Subject: D/2025/488

Re: Objection to Development Application D/2025/488 — 134–136 Botany Road, Alexandria, NSW 2015

I am writing in relation to Development Application D/2025/488, submitted by McKenzie Architects International Pty Ltd, proposing demolition and construction works at 134–136 Botany Road, Alexandria.

PROPOSAL: REDUCE BUILDING HEIGHT AT REAR TO REDUCE SHADE IMPACT. NEW BUILDING FOOTPRINT COULD THEN BE EXTENDED FURTHER WEST WITH MINIMAL IMPACT.

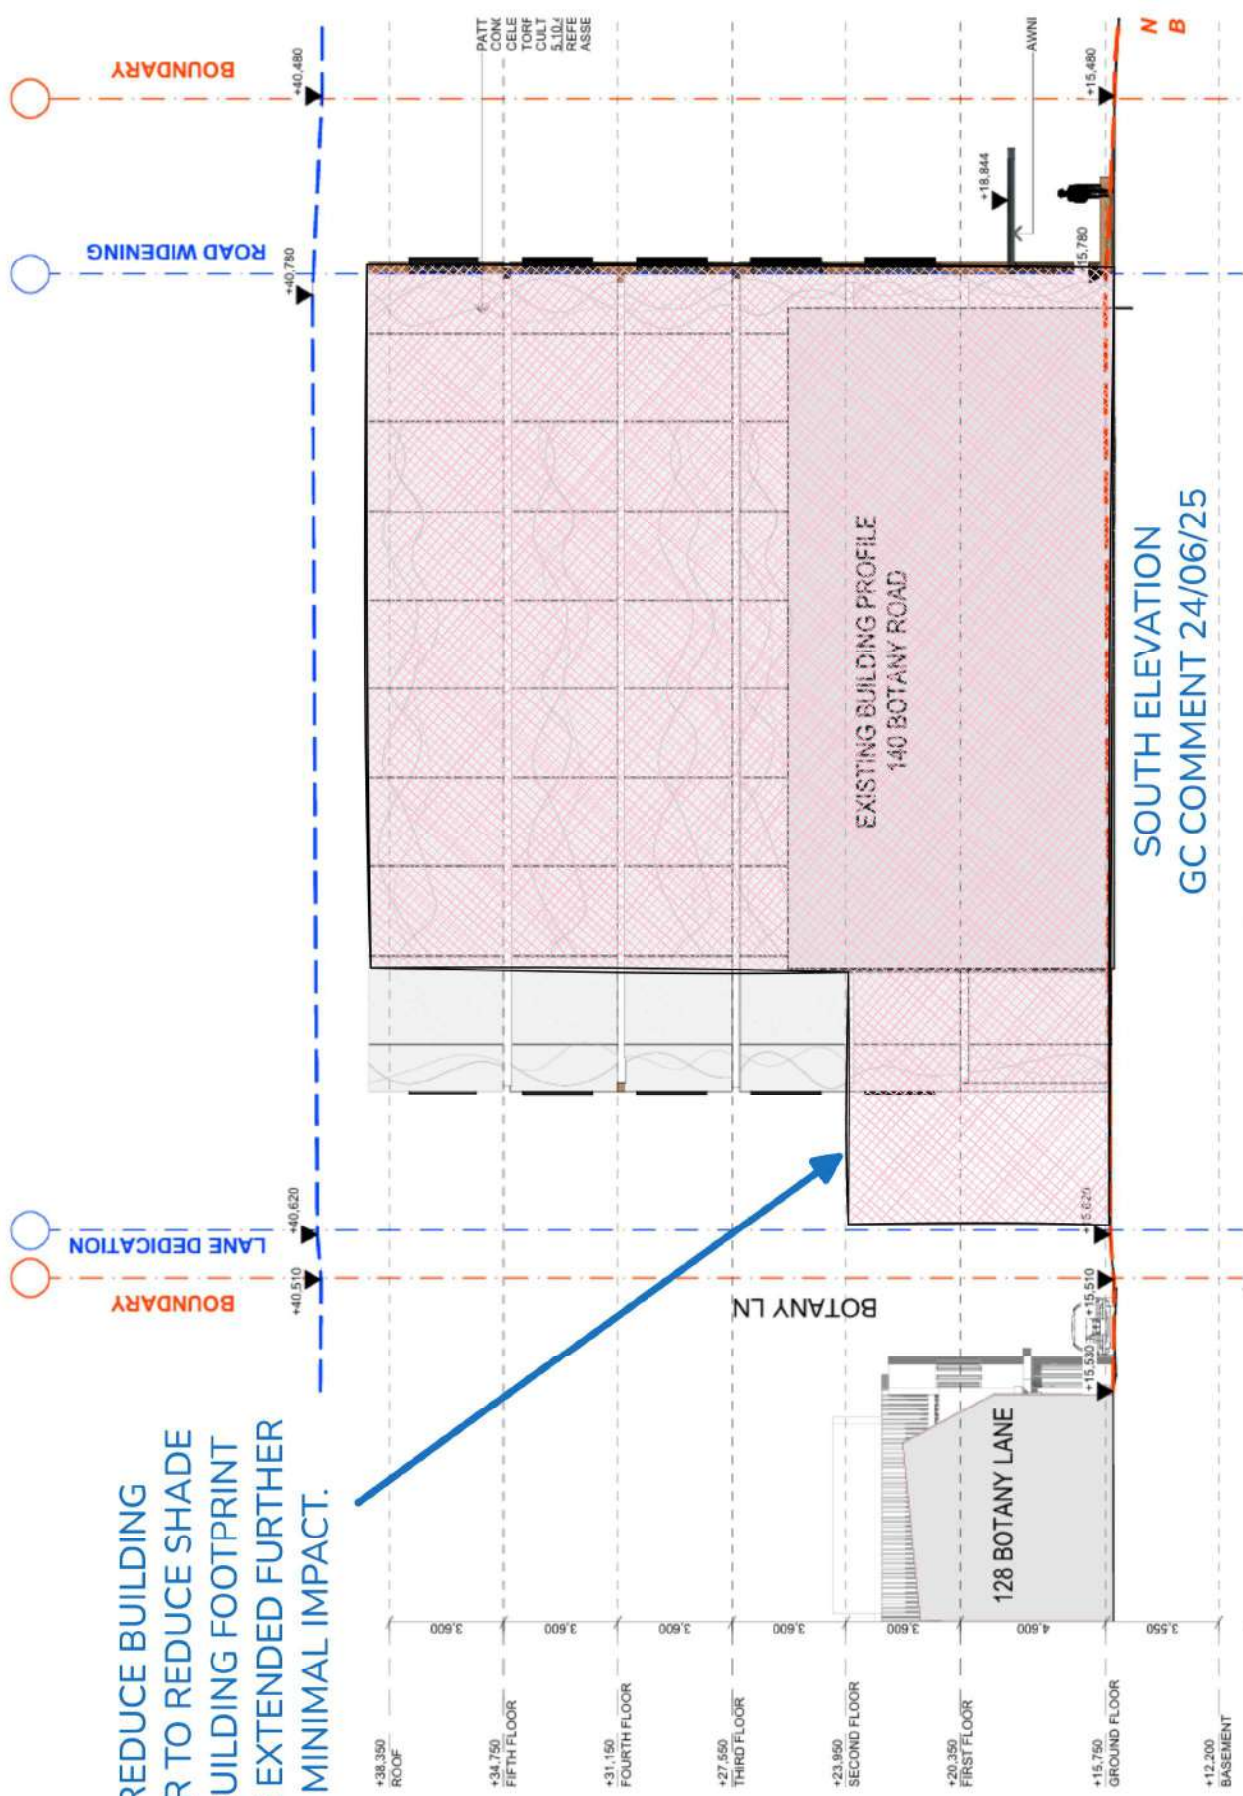
I have attached a proposal for modifications to the proposed building design to alleviate the concerns raised above. This proposal would involve reducing the height of the proposed development at the Western boundary to minimise the shade impact on neighbouring properties. This could also allow for the building footprint to be extended further West (if desirable) with minimal shade impact.

SOUTHERN ELEVATION
Buckland Street

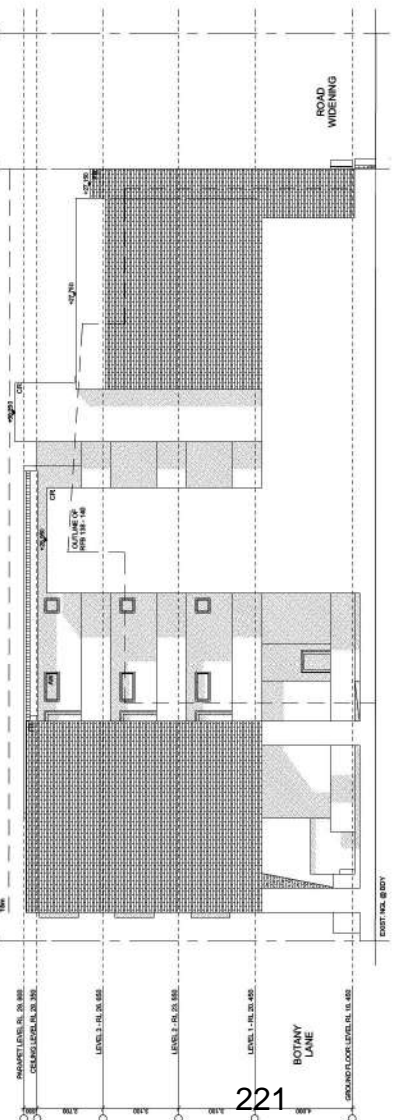
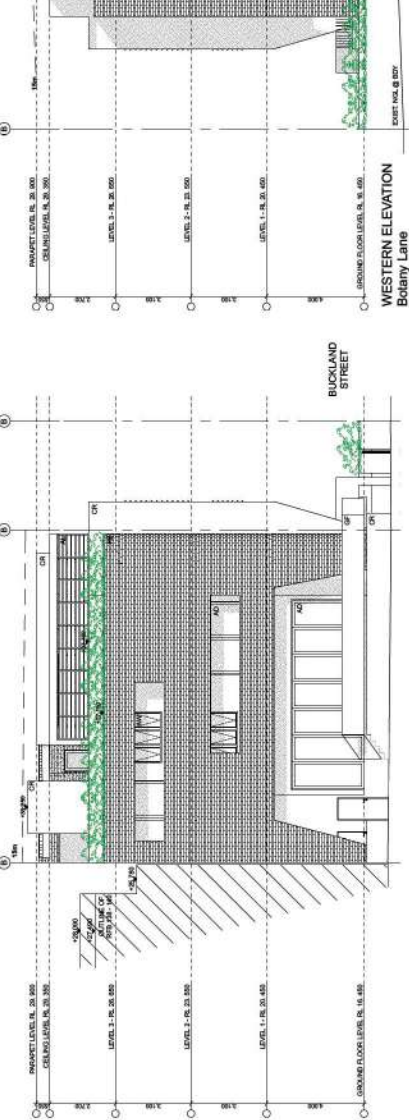
3. The submitted architectural plans provide little information on the Southern elevation. I would like to enquire if the commercial development will have windows that face into the apartments of our building.

3. The submitted architectural plans provide little information on the Southern elevation. I would like to enquire if the commercial development will have windows that face into the apartments of our building.

EXISTING SHADOW DIAGRAMS
9am - 3pm - 21 June

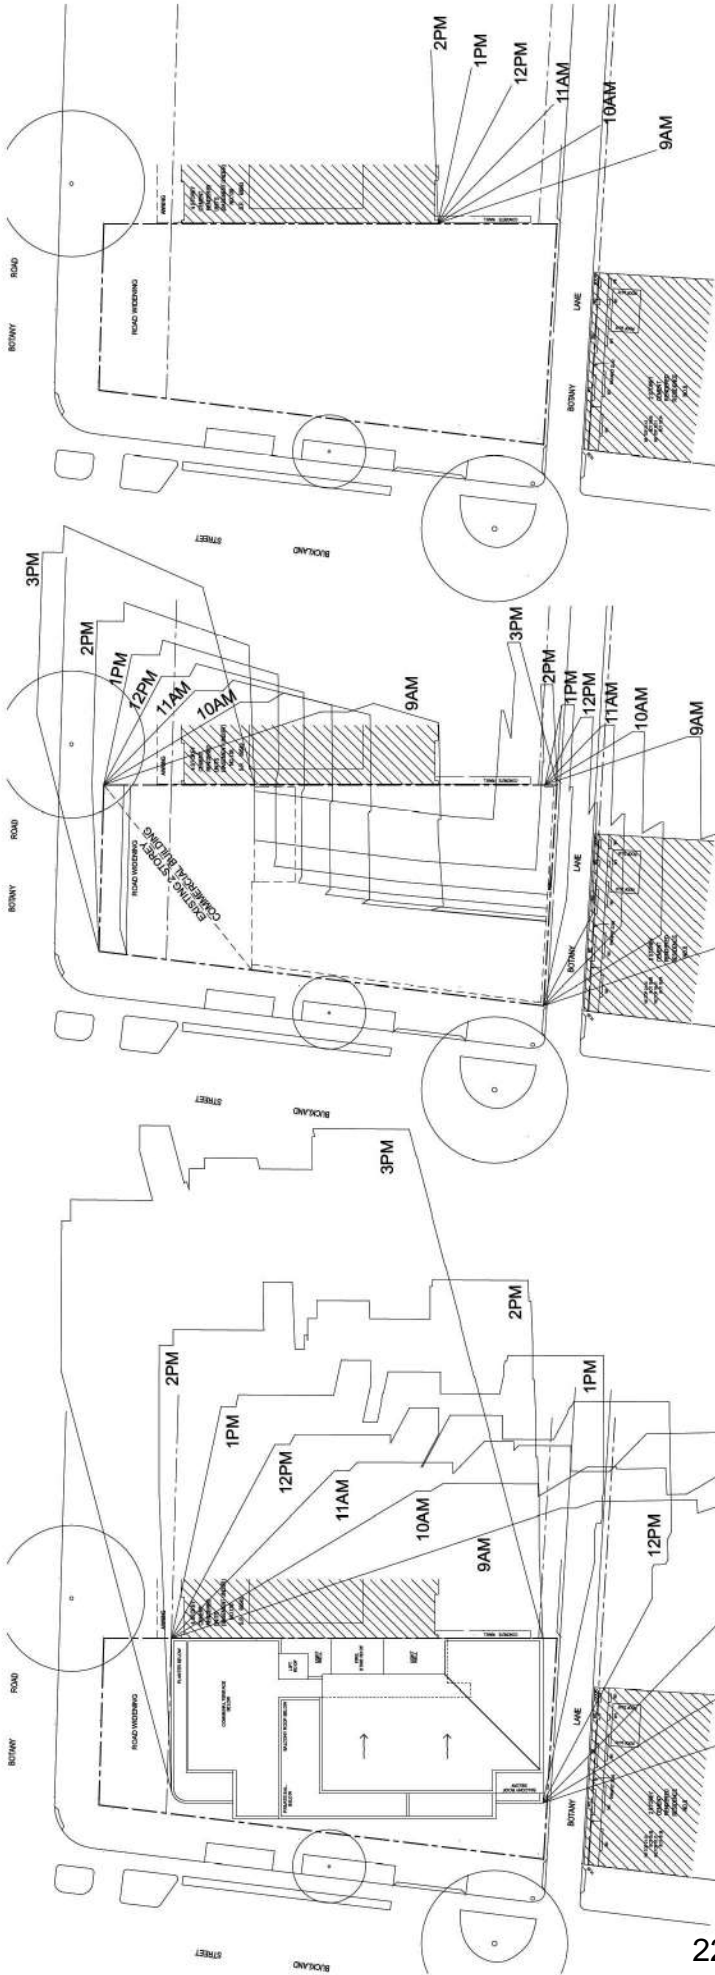
1. The DA architectural shadow drawings appear to grossly overestimate the amount of shadow cast by the existing building at 134-136 Botany Road, presumably to make the shadow impact of the proposed development appear less by comparison. I've attached photos taken from Botany Lane at 3pm today 27/08/23, which show the entire Western face of 138-140 Botany road covered in sunlight, whereas the shadow plan on Drawing A4103 implies that the building is completely shaded at this time (snippet above). Our strata committee and other owners have similar concerns for the apartments along the Eastern elevation, and the penthouse balconies on the Northern perimeter, which will lose all natural light due to the development.

1. The DA architectural shadow drawings appear to grossly overestimate the amount of shadow cast by the existing building at 134-136 Botany Road, presumably to make the shadow impact of the proposed development appear less by comparison. I've attached photos taken from Botany Lane at 3pm today 27/08/23, which show the entire Western face of 138-140 Botany road covered in sunlight, whereas the shadow plan on Drawing A4103 implies that the building is completely shaded at this time (snippet above). Our strata committee and other owners have similar concerns for the apartments along the Eastern elevation, and the penthouse balconies on the Northern perimeter, which will lose all natural light due to the development.
